TECH-NEWS

Handle Bracket Update**October, 2010**

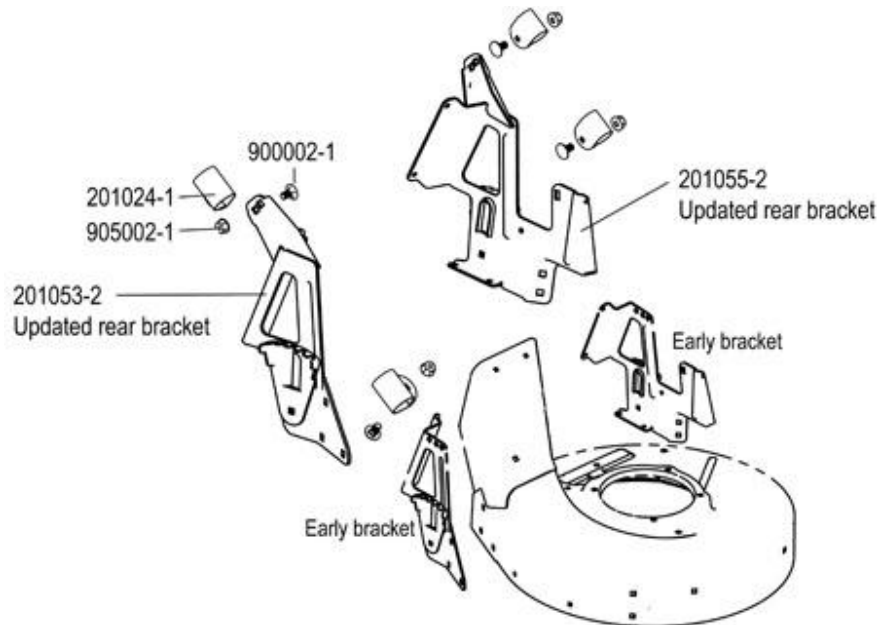
We have received a few complaints about the handle attachment to the mower deck:

- The handle tubes are "flexing" too much
- A few clamps and rear brackets have broken

To address these complaints we have redesigned the rear handle brackets per the illustration. The new design separates the tube clamps (201024-1) and contributes to an overall stronger attachment of the handle to the mower.

Kit Part #: [996001-1](#) Rear Bracket Update Kit. List price \$30.00

- 4ea 201024-1 Handle Clamp
- 1ea 201053-2 Bracket, Right Rear Assembly
- 1ea 201055-2 Bracket, Left Rear Assembly
- 4ea 900002-1 Carriage Bolt, M8x16
- 4ea 905002-1 Flange Nut Locking-M8

All mower deliveries as of September 15, 2010 include the new brackets and handle attachments.
